HEATUP AND COOLDOWN LIMIT CURVES
FOR THE
BRAIDWOOD UNIT 1 REACTOR VESSEL
(CAPSULE U)

Prepared by Westinghouse Electric Corporation
for the Commonwealth Edison Company

Subject: Braidwood Unit 1
Heatup and Cooldown Curves

Commonwealth Edison Company
Braidwood Unit 1
LTOPS Setpoint Reanalysis

Figure 1. Braidwood Unit 1 Reactor Coolant System Heatup Limitations (Heat up rate up to 100°F/hr) Applicable for the First 32 EFPY (With Margins 10°F and 60 psig for Instrumentation Errors)

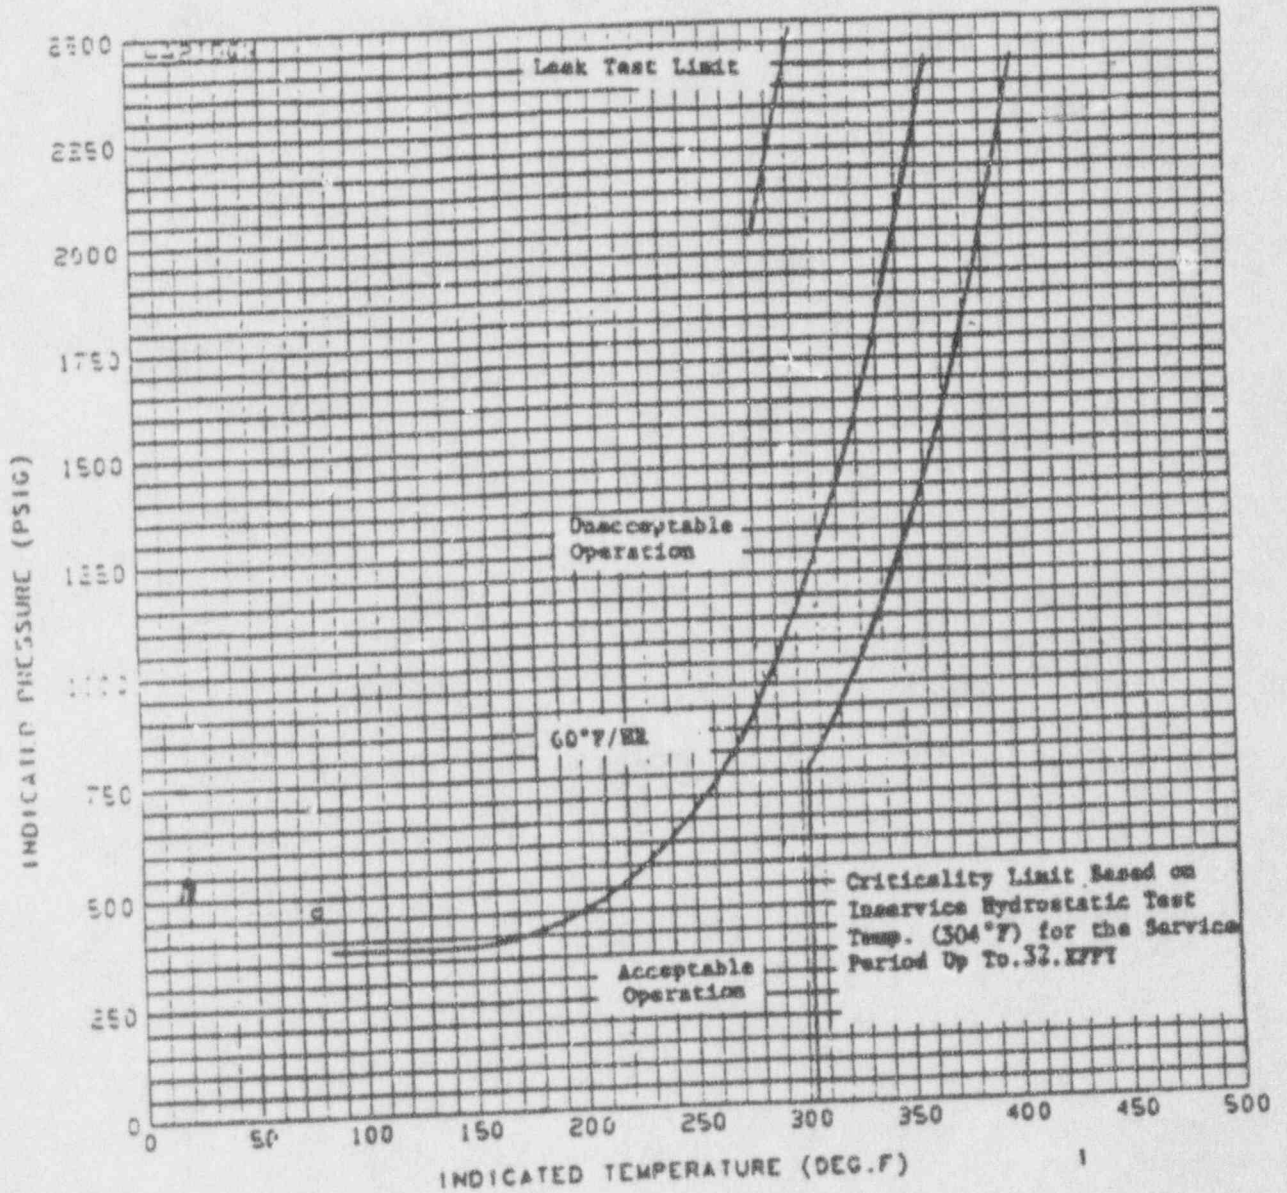
Attached Figures 1 and 2 replace Technical Specification Figures 3.4-2a and 3.4-3a, respectively.

Figure 3 Nominal PORV Pressure Relief Setpoint vs. RCS Temperature for the Cold Overpressure Protection System Applicable to 32 EFPY (Unit 1)

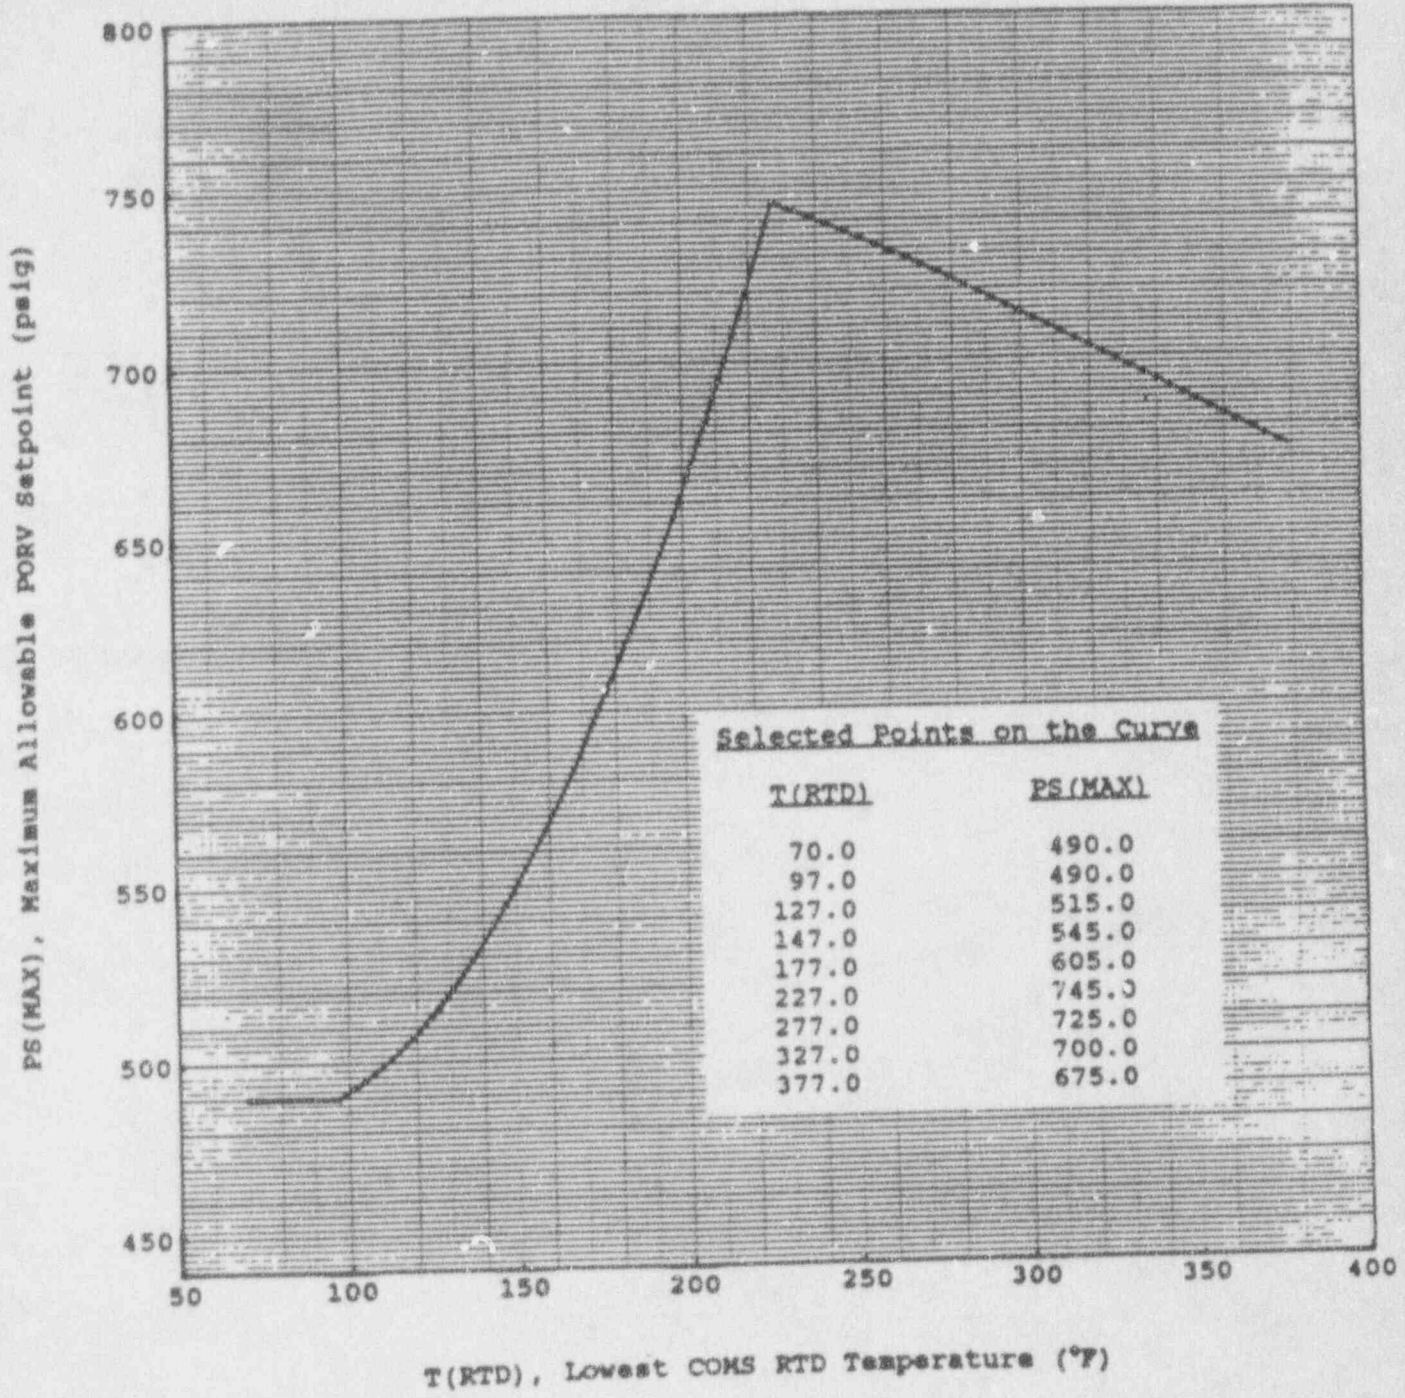
Attached Figure 3 replaces Technical Specification Figure 3.4-4. It is suggested that Figure 3.4-4a be deleted from the technical specifications. The Westinghouse version of the LCO (Amendment 33) makes no reference to this figure.

The replacement figure is applicable to the lowest reading RTD (consistent with the current tech. spec. figure), and includes a 27 °F correction for temperature streaming and instrument uncertainty. The setpoints were selected to prevent overpressures from exceeding the 800 psig PORV piping limit, thus the setpoint reduction after about 227 °F reflects the increasingly large overpressures with temperature due to heat injection events.
